**BEFORE THE PUBLIC UTILITY COMMISSION
OF OREGON**

LC 66

PORTLAND GENERAL ELECTRIC
COMPANY,

Staff's Initial Comments

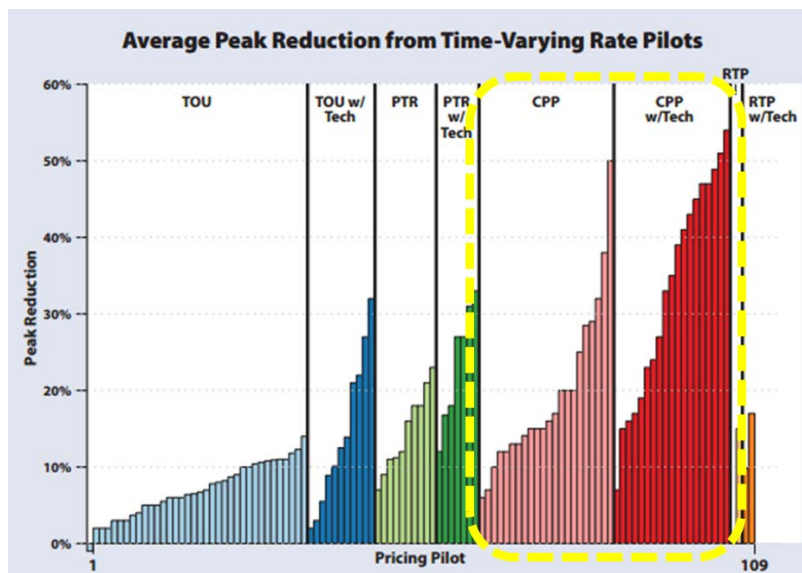
As a result of simply lumping these various demand response resources into a simple "incremental DR" bucket which becomes available in 2020, Staff, PGE, and Stakeholders do not gain insight into the shape, costs, benefits, operational characteristic and therefore the viability of the DR resources PGE seems to be modeling.

From a resource supply perspective Staff does not understand the assumption in PGE's response IR 59 that first shows a rapid demand response growth in 2020, some additional build in 2021 and then a decline in the resource through 2031. Under PGE's IRP load growth assumption, which shows increasing load growth year over year, the expectation would be that DR opportunity also grows over time proportionately. However, in PGE's analysis DR opportunity does not increase over time but instead lessens over time. It is not clear to Staff why increases in load do not correspond to increases in demand response opportunities.

11. PGE should describe which of the five types of DR were added as "incremental DR" and their estimated MW contribution to the revised total of DR in response to IR 59.

2014 Average Energy Resource Mix (availability)⁶⁹

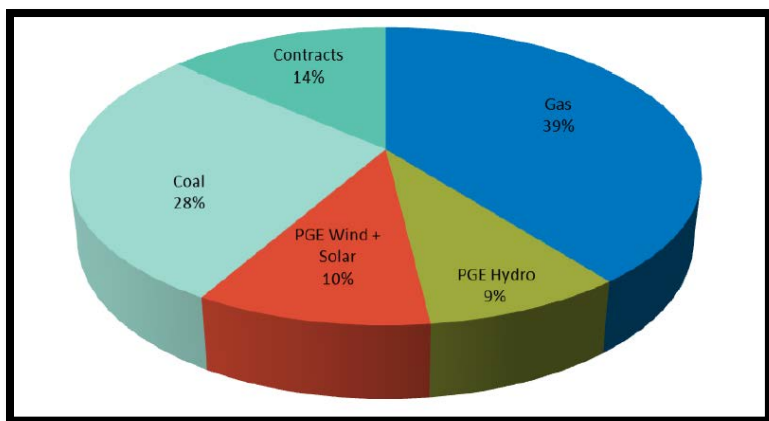
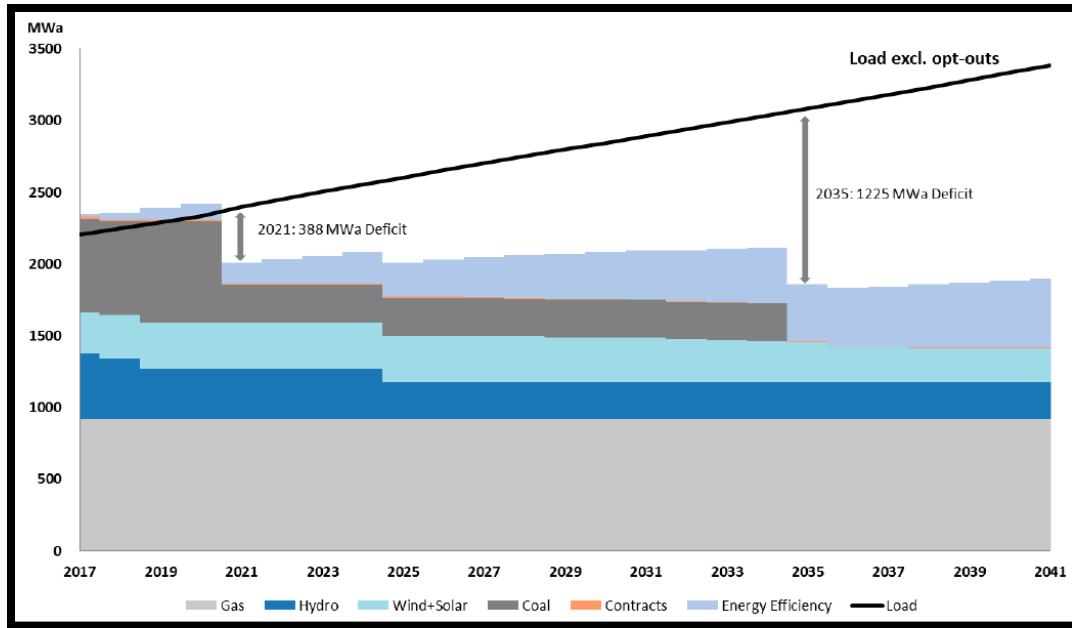
In PGE's 2013 IRP acknowledgement the Commission supported PGE's action item to renew all cost-effective hydro contracts under an alternative acquisition method outside of the RFP process. In the 2016 IRP PGE states it will, "seek the renewal, or partial renewal of expiring legacy hydro contracts," but Staff noted the drop off in hydro capacity between the last IRP and hydro going forward with little to no explanation of the results or activities around renewing existing hydro contracts or the availability of new hydro contracts.⁶⁸ In 2014, hydro represented 20 percent of PGE's energy resource mix. In 2017 it drops to 9 percent. In 2021, hydro will drop even further as a percent of energy resource mix. See the three graphs below:

Despite Commission Order No. 14-415 from LC 56 encouraging PGE to renew existing hydro contracts outside of an RFP process, it appears that several of these renewals have not taken place or are projected to not take place in the near future. If correct, the declining presence of hydro in PGE's resource mix comes in the absence of any discussion in the 2016 IRP around the ongoing difficulties in renewing existing hydro contracts. This echoes questions from the Commission at its December 20, 2016 public meeting about the status of any contract negotiations, especially hydro at Mid-C.

- 28.** PGE should describe the change in the region's hydro market that has led to the decline of hydro in PGE's resource capacity mix since 2013.
- 29.** Can PGE share any information that would help staff better understand PGE's strategic shift in the preferred approach to acquiring hydro resources?
